ENGINEERING PLANS — AMENDMENTS

Casa Abadia · Praceta da Abadia, Lote 13 · Ericeira, Mafra

Rev. 2 · 26 August 2026 · Owner: Sébastien Maillard / Natasha Santric

Four amendments to the engineering designs of July 2026 (GAP LR, process 3775). Each is to be re-engineered and priced by the responsible contractor.

Ref: AVAC, drawing 03 — Planta do Piso 1, Ventilação

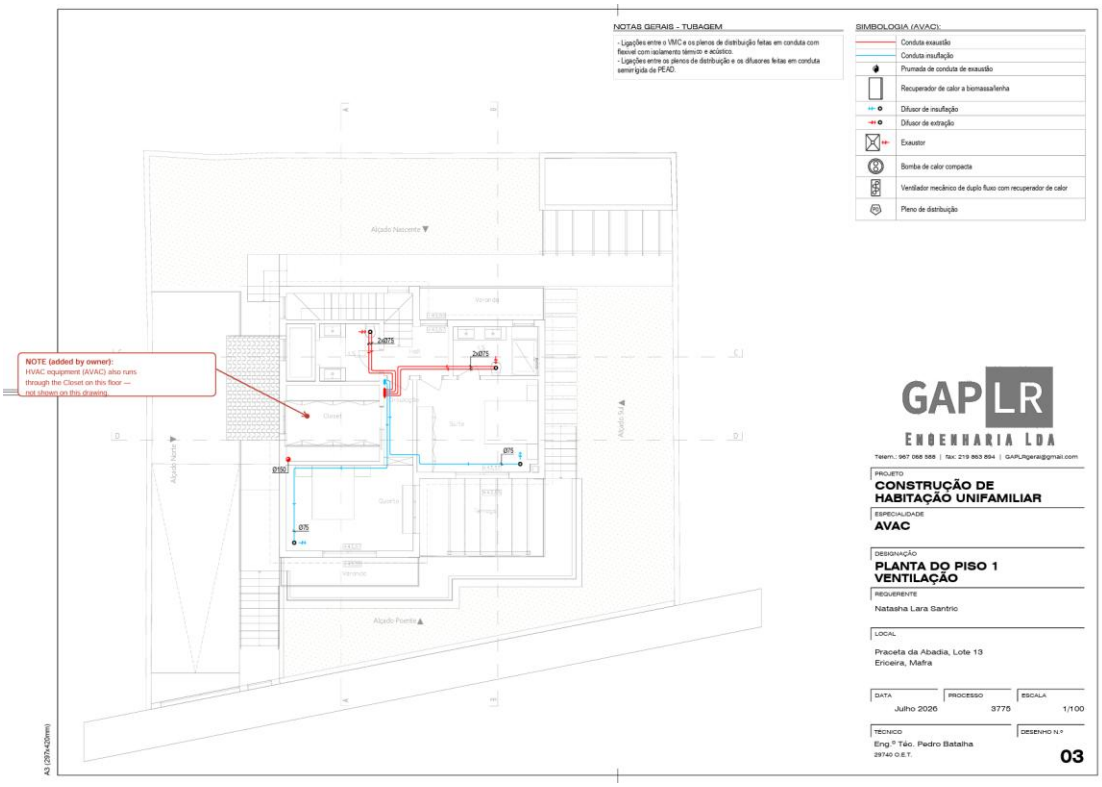
Goal. The 1st floor walk-in closet (9.30 m²) to be served by the AC and VMC systems. It is not on the current drawing.

- **Wood-Home:** duct openings through the structural panels to be made in the factory, not cut on site.
- Extraction is the priority — humidity and odour control.
- An air return path is needed (door undercut or transfer grille).
- Confirm the impact on the thermal calculation and on heat pump sizing.
- Duct routing to be coordinated with the closet joinery before manufacture.

Required by: Before the structural panels and closet joinery are manufactured.

Ref: Rede de Águas Residuais, drawing 02 — Planta do Piso -1

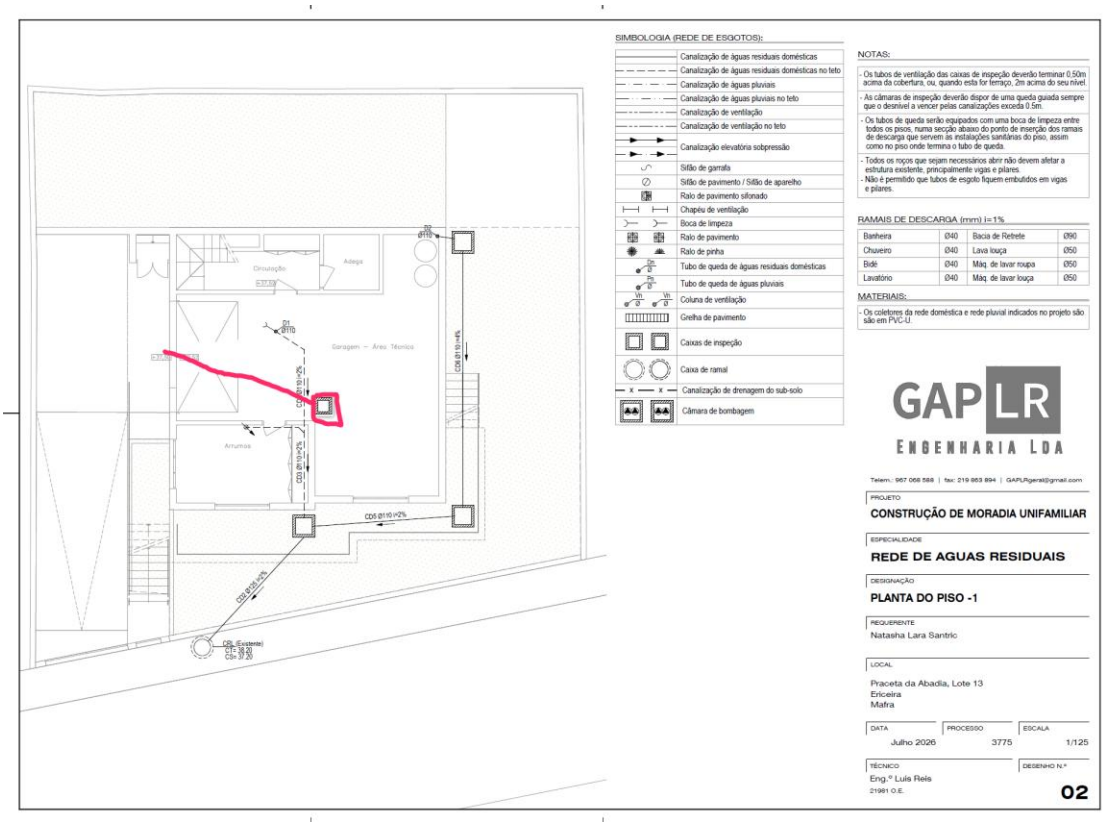
Goal. Leave capped waste and water connections in the basement so a tap and shower can be added later without breaking the slab.

- Connect into the existing inspection chamber (marked on the drawing).
- **Critical —** confirm there is enough fall for a shower trap: basement floor is at +37.50, the existing connection invert at 37.20. If gravity is insufficient, provide a pumping chamber.
- Include venting; a trap without a vent will siphon.
- Add cold and hot water stubs in the same operation.
- Stub-outs to be capped, photographed and their positions recorded before the pour.

Required by: Before the foundation slab is poured. This item cannot be recovered later.

Ref: Planta da Cobertura — to be marked on the electrical drawing (IE), not ITED

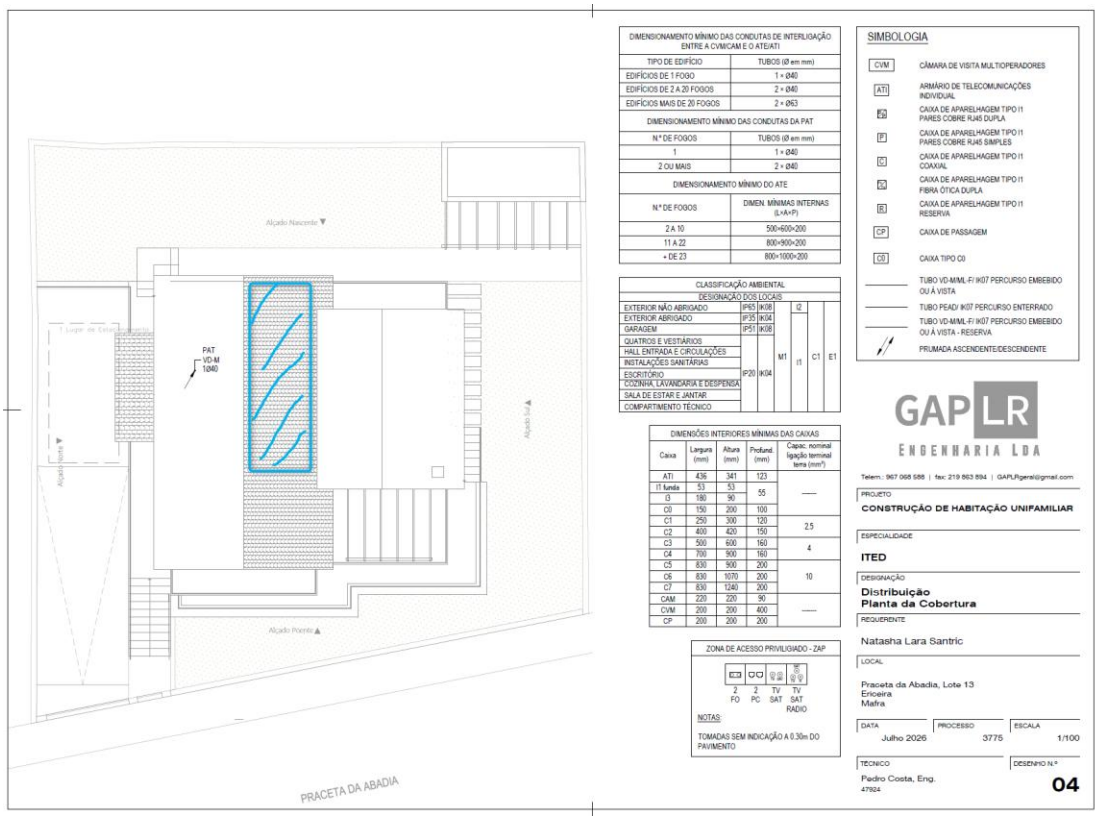
Goal. Roof and electrical installation prepared for a future PV system, so that fitting it later requires no work on the sealed roof or the finished walls.

- **Pitched roof —** the array goes on the south-facing plane only.
- Initial target ~9 m² (≈ 2 kWp). Size the provision for expansion to about 5 kWp — extra provision now costs very little.
- **Wood-Home:** structural anchors and waterproofed penetrations built into the roof panels in the factory; confirm the additional load is covered by the structural design.
- **Electrician:** DC conduit roof → technical room, separate from AC and ITED; reserved breaker space in the board; inverter and battery position; earthing and bonding.
- Panel layout to be proposed by the contractor.

Required by: Before the roof panels are manufactured.
